Office of Environmental Sustainability,
Environmental Protection Agency,
P.O. Box 3000,
Johnstown Castle Estate,
Co. Wexford

Re: Mag World Ltd. P1148-01

I refer to previous Agency correspondence of 13th January last. Please find detailed below the response to the issues raised.

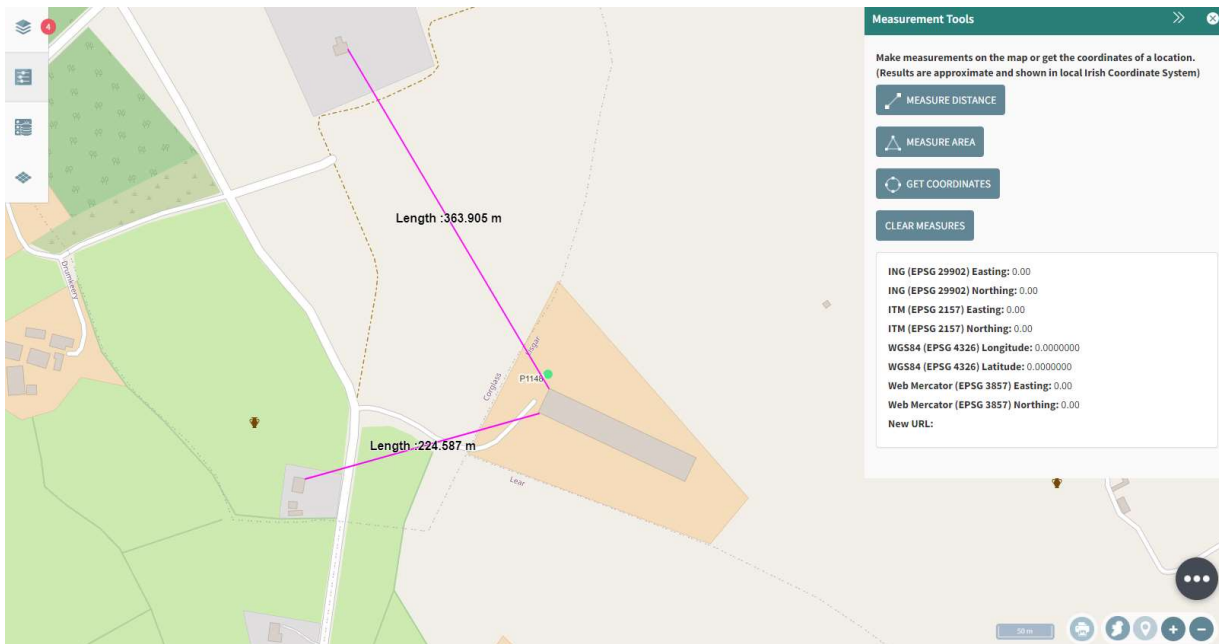
- d) Provide a map outlining the surface water pathway(s) between storm water discharge points and the local land drains/watercourses; and

- e) Clarify how wash water is kept separate from clean storm water and how wash water is diverted to the wash water tanks.

There is only one yard area (to the front) that may be soiled (During emptying of the houses c. 5 times per annum). A diversion system is in place whereby water of this area can be diverted to the soiled water tanks and diverted back to the storm water at the end of cleaning and after the concrete apron has been washed clean.
